Re: 2330 SW Old Port Road

Vista Structural Engineering, LLC, was asked to address the following framing inspection item for the house being built at 2330 SW Old Port Road:

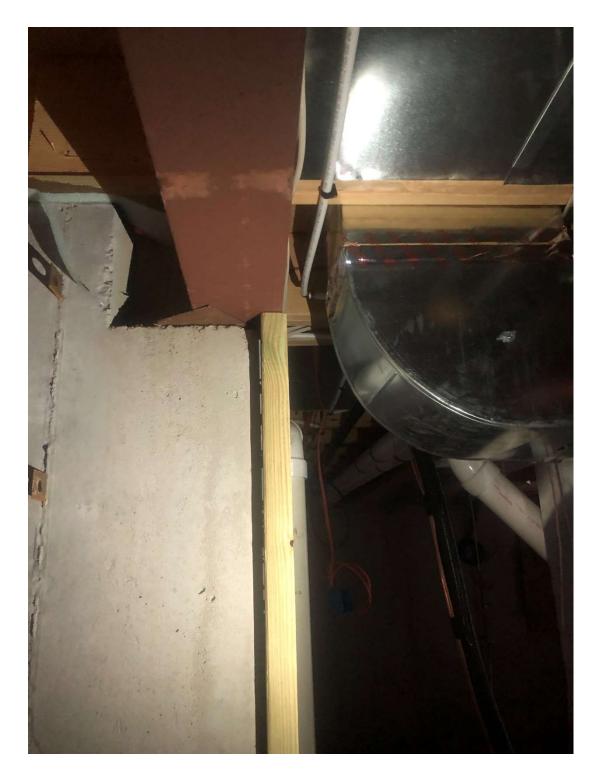
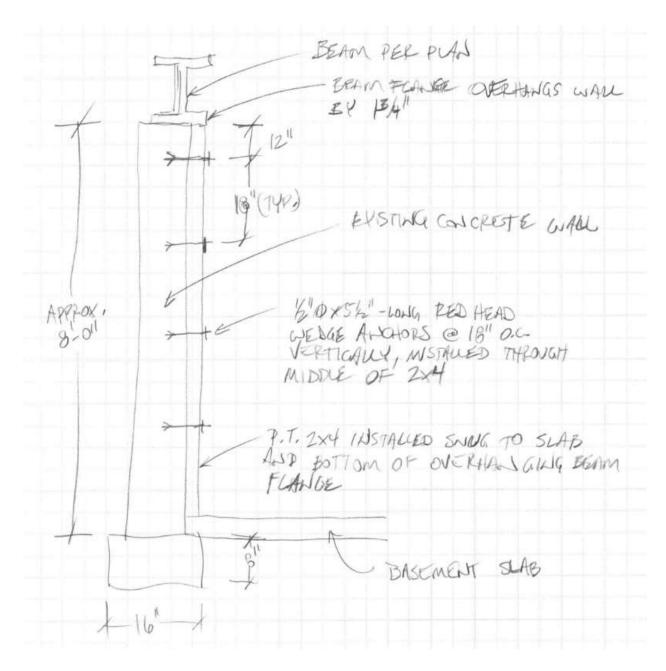
A floor beam is not sitting fully in pocket at foundation wall. Roughly 1-¾" is overhanging due to foundation being out of square. Can a 2x4 be bolted to the foundation wall to fully support the beam? A treated 2x4, or a 2x4 with a moisture barrier installed, bolted to the concrete foundation per the attached sketch, will sufficiently support the beam at the foundation wall. Reference the attached picture and sketch on the following pages. We approve of this attached detailed solution.
